TOWNEPLACE SUITES (fka FAIRFIELD INN & SUITES) JSP 18-66

TownePlace Suites JSP 18-66

Consideration at the request of Novi Superior Hospitality, LLC for Planning Commission's approval of Preliminary Site Plan and Final Site Plan and Storm Water Management plan. The applicant is proposing a 5 –story hotel with 120 rooms on Unit 3 of Adell Center Development. The proposed site plan proposes associated parking and other site improvements. The subject property is part of a Planned Rezoning Overlay (PRO) development for Adell Center.

PLAN REVIEW CENTER REPORT
September 5, 2023
Planning Review
Towne Place Suites (fka Fairfield Inn & Suites)
JSP 18-66

SHEET
C3.0

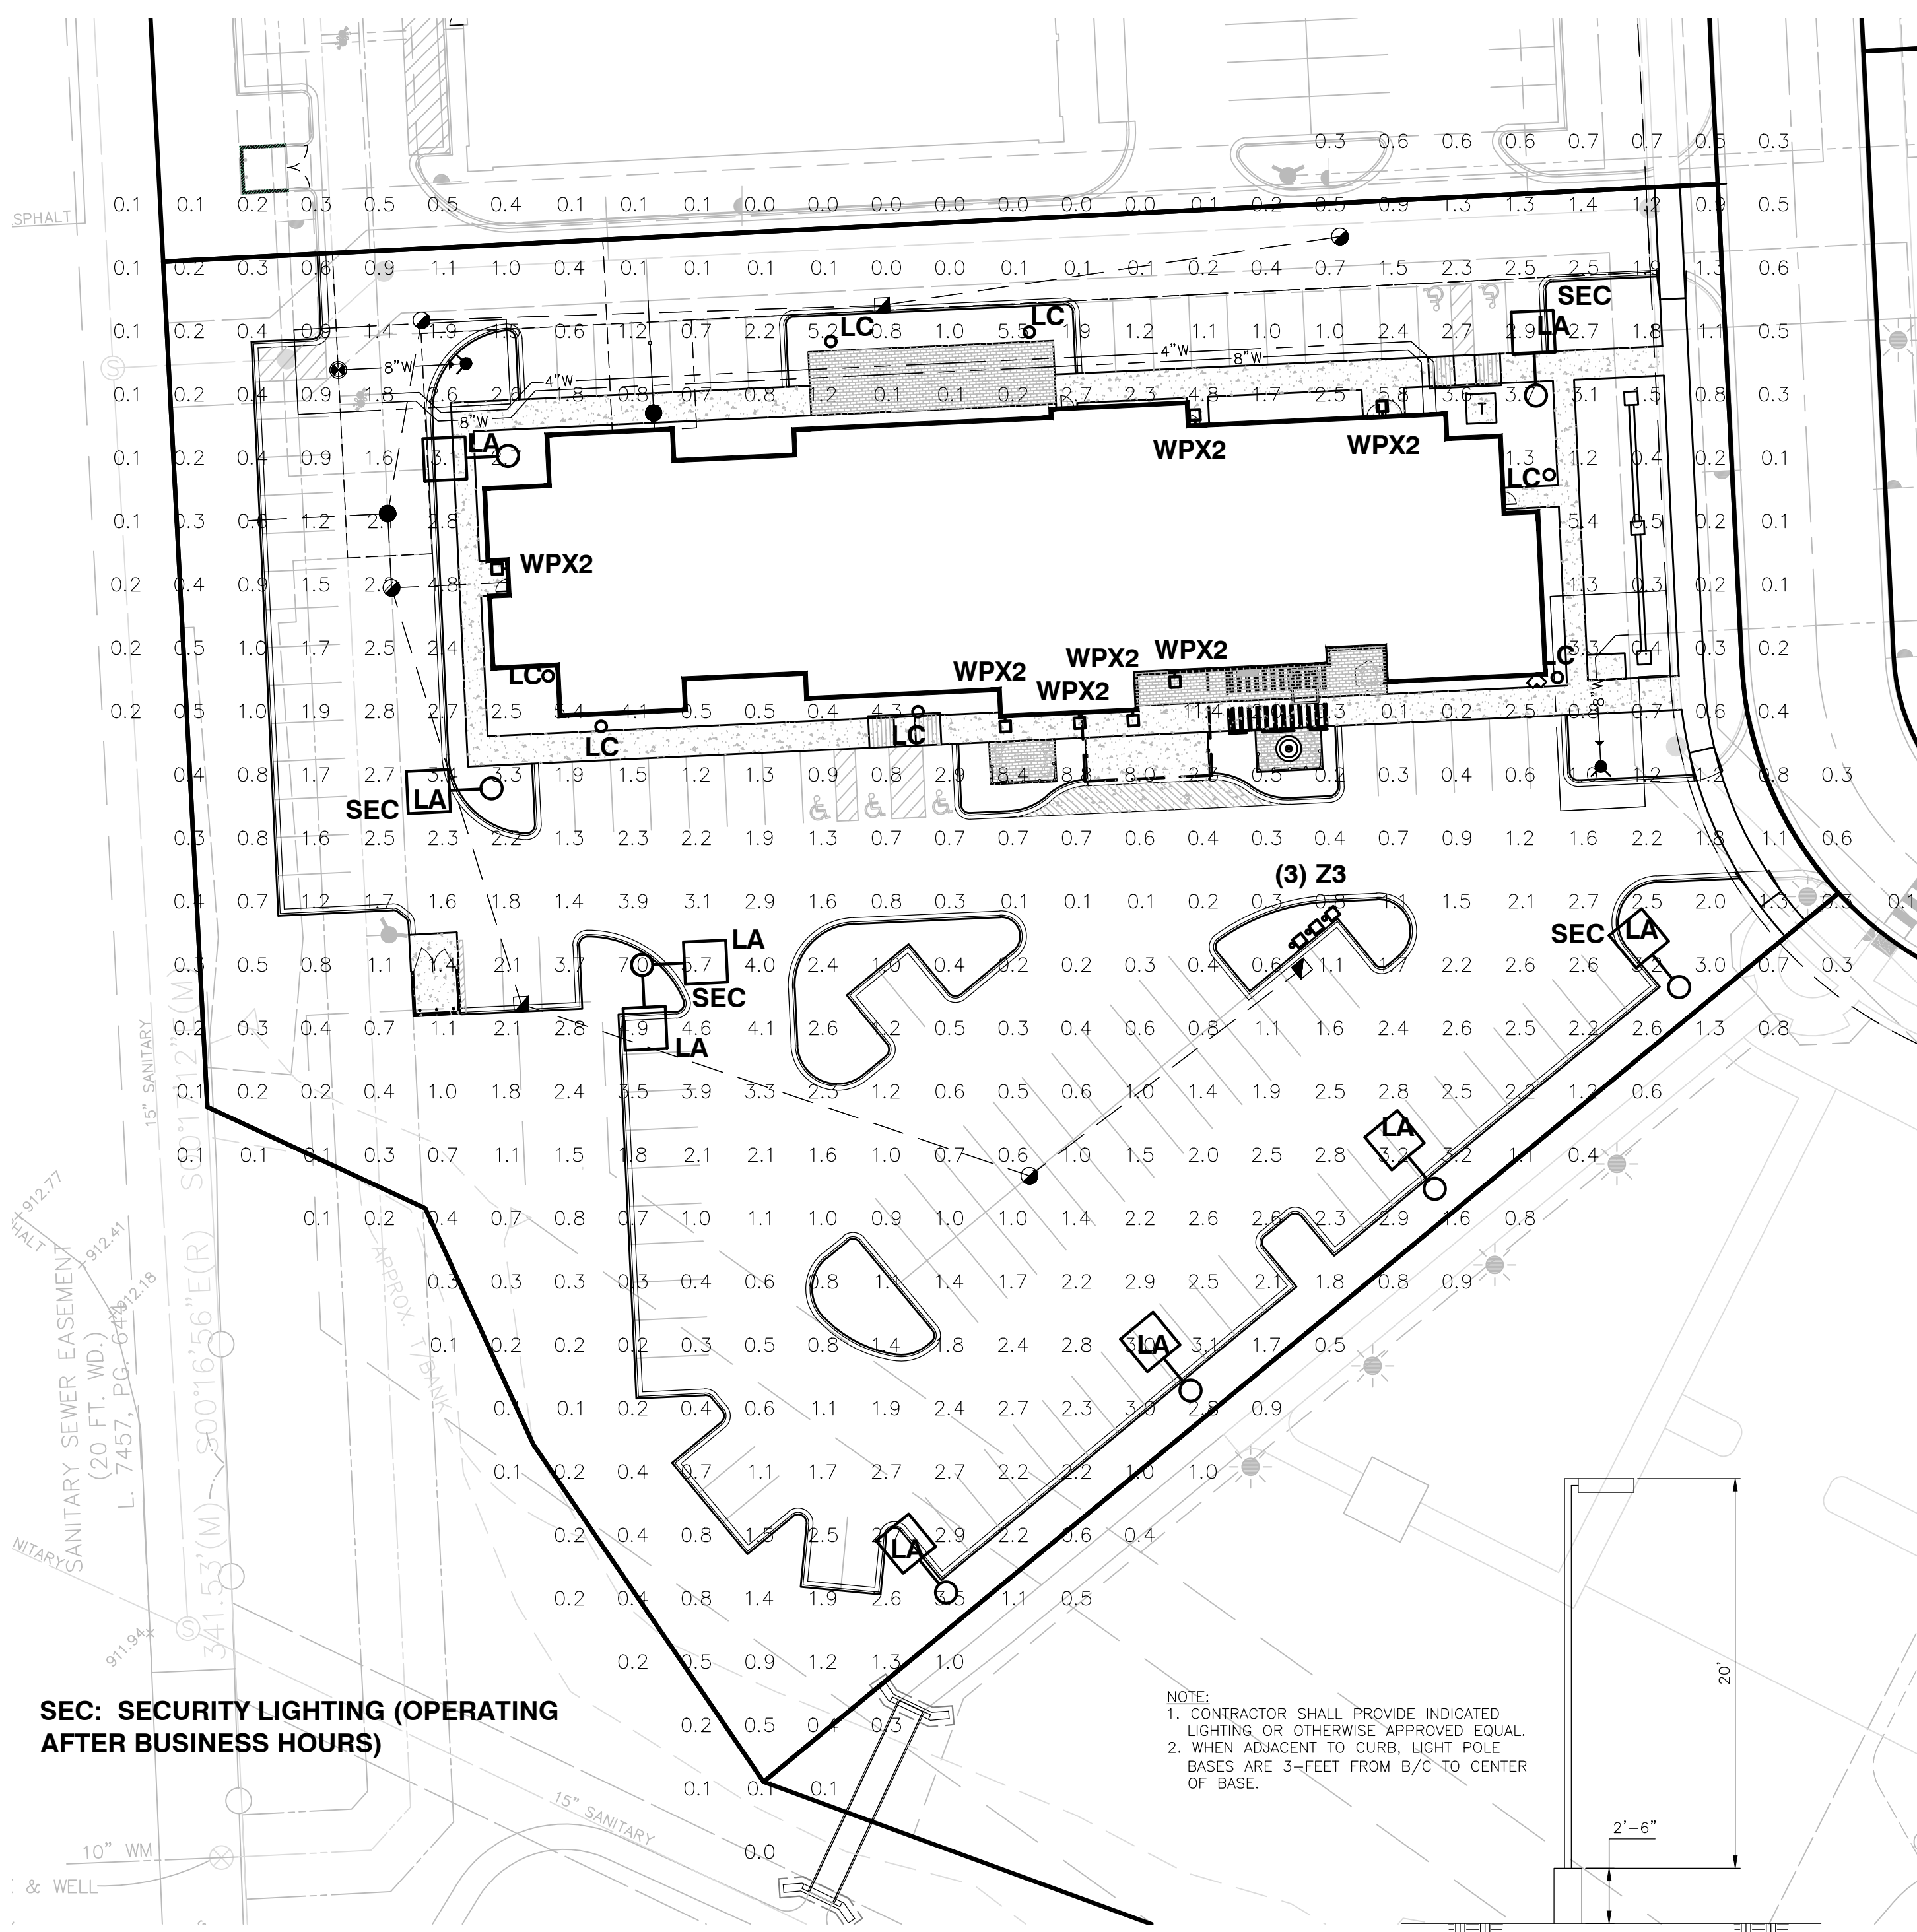
- DEVIATION REQUEST: Deviation from frontage along a public street. The deviation is approved in the Adell Center PRO Agreement.
- DEVIATION REQUEST: Request from Planning Commission to allow deviation from the size of the loading zone as indicated on sheet C3.0. A dedicated loading zone is located in the rear of the building area. There is no restaurant and only continental breakfast is served, therefore food service deliveries are only required on a weekly basis. Laundry services are needed on a bi-weekly basis. Delivery times are coordinated with non-peak guest hours. Typical delivery trucks are "Box Trucks" that are similar size to UPS trucks and can utilize standard parking spaces. A deviation from Section 3.27.1H is requested. Notation has been provided on sheet C3.0.

- The bicycle parking pad area is 6'-0" x 9'-0" in size with dimensions provided on sheet C3.0 with 2.5-foot double spacing between loops.
- The building mounted lights have been indicated on sheet C3.1 with updated photometric levels and computations. Several bollard lights have been removed.

- Hours of Operation are included in the "Operational Data" on sheet C3.0.
- Sheet C2.0 "Survey Plan" includes easement information.

- The dumpster dimension of 10'x10' is noted on sheet C3.0.
- Detectable warning plates are noted on sheet C3.0 and detail provided on sheet C6.0.
- The existing sidewalk along Adell Center Drive is noted as existing on sheet C3.0.
- A "Pavement Base Material Note" has been added on sheets C3.0 and C6.0 regarding the use of 21AA crushed concrete within 100-feet of a water body.
- A License Agreement for the placement of the "Landscape Wall" along the frontage of Adell Center Drive within the water main easement will be submitted.
- No retaining walls are proposed with the project.

SHEET
C5.0

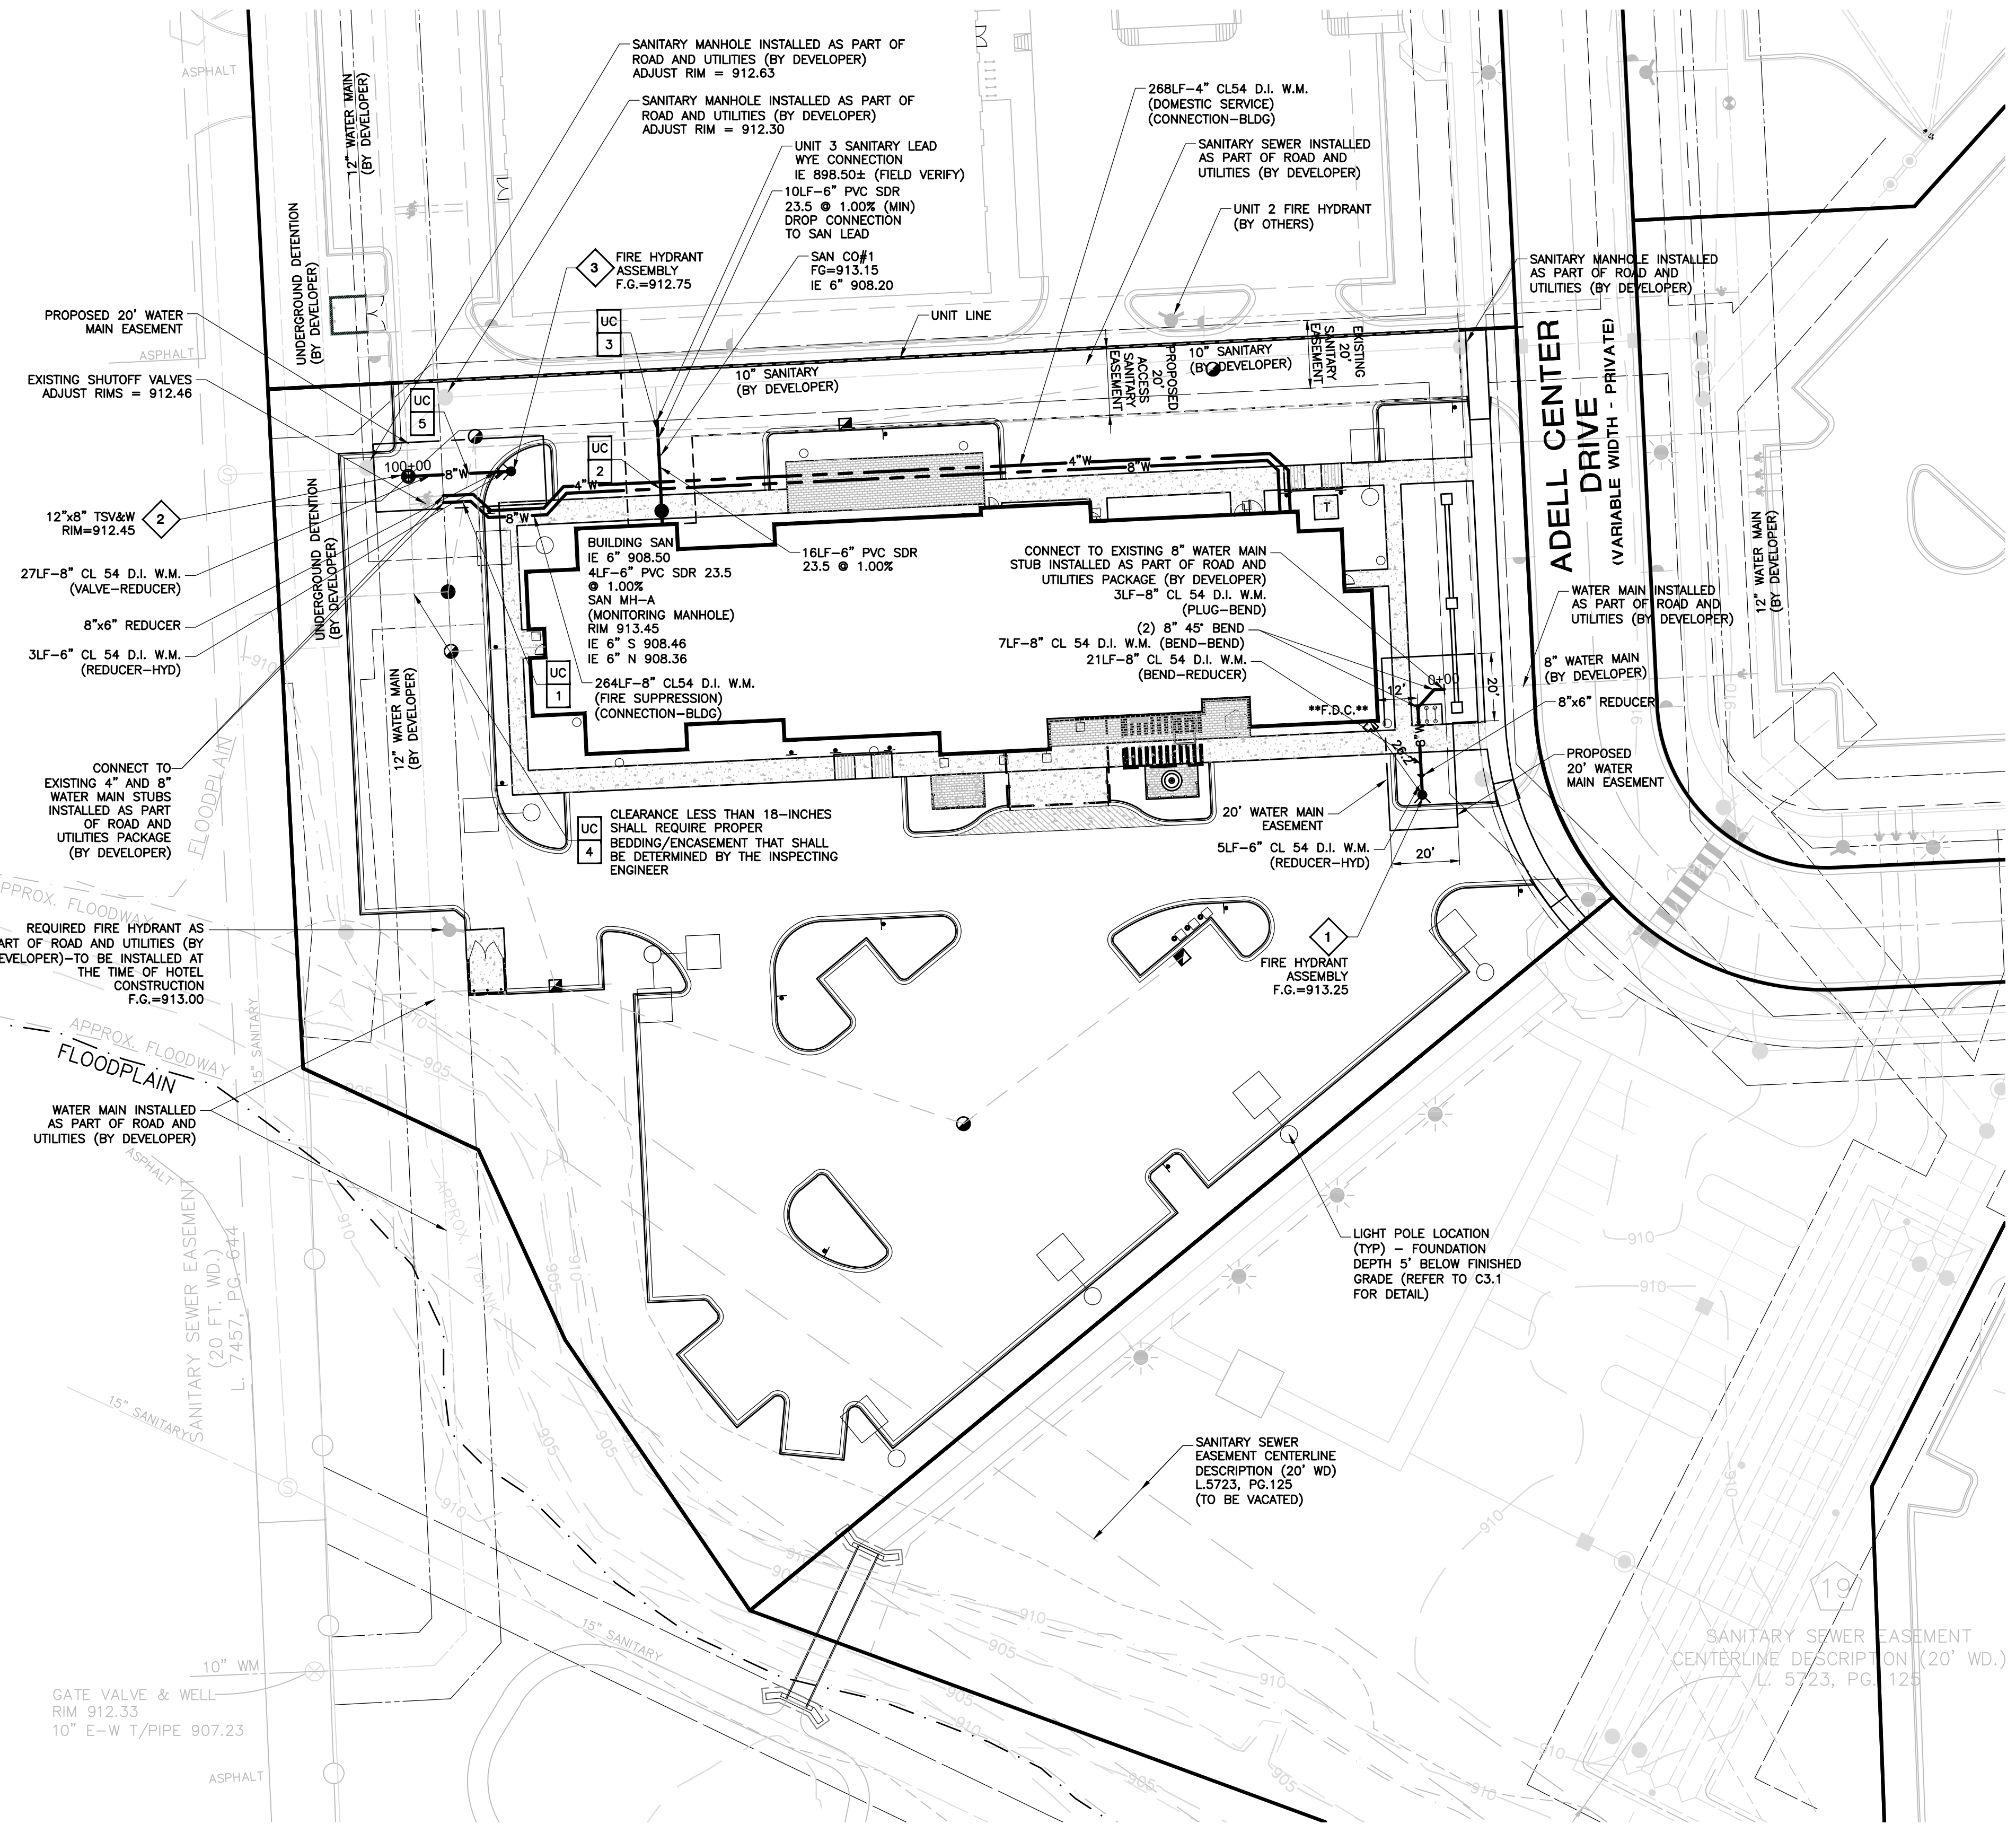
- A notation has been added to C5.0 indicating work to be in compliance with the City of Novi standards.
- Existing utilities have been labeled accordingly.
- City standard details have been removed from the current set and will be only incorporated at the time of Stamping Set.
- The signage table has been updated on sheet C3.0.
- Compacted sand backfill is indicated in both the plan and profile views.
- A note regarding dewatering is included in "General Notes" sheet C5.0.

- Irrigation is proposed and an irrigation plan will be included.
- The "City of Novi Irrigation System Note" has been added to sheet C5.0.

Figure 1

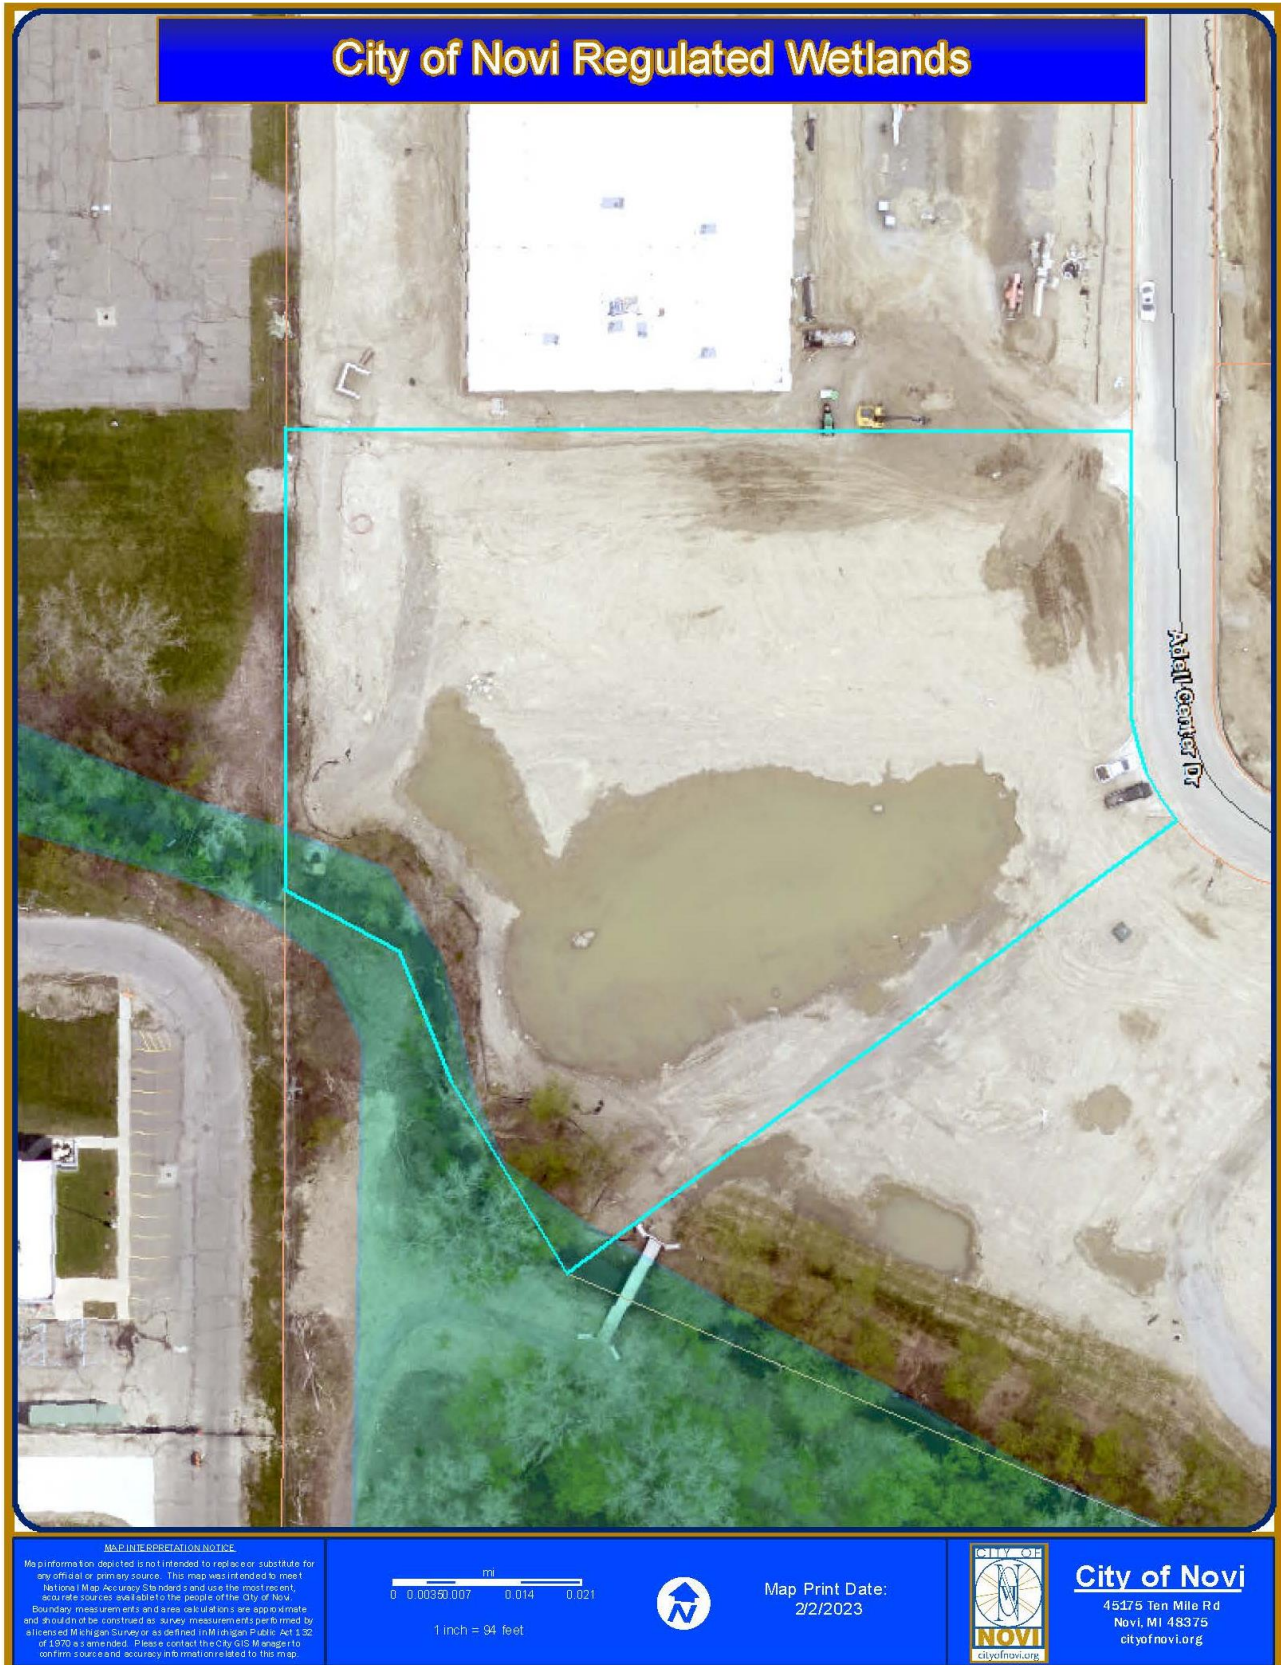
MSG compared the rFSP to the Fairfield Stamping Set and observed the proposed wetland impacts are the same. Specifically the rFSP proposes 1,240 square feet of temporary impact within the 25-foot setback of Middle Rouge River/Wetland 1 and does not propose direct impacts to on-site wetlands/watercourses. MSG concludes ECT's May 12, 2020 *Authorization to Encroach Upon 25-Foot Natural Features Setback* remains valid for the project as proposed.
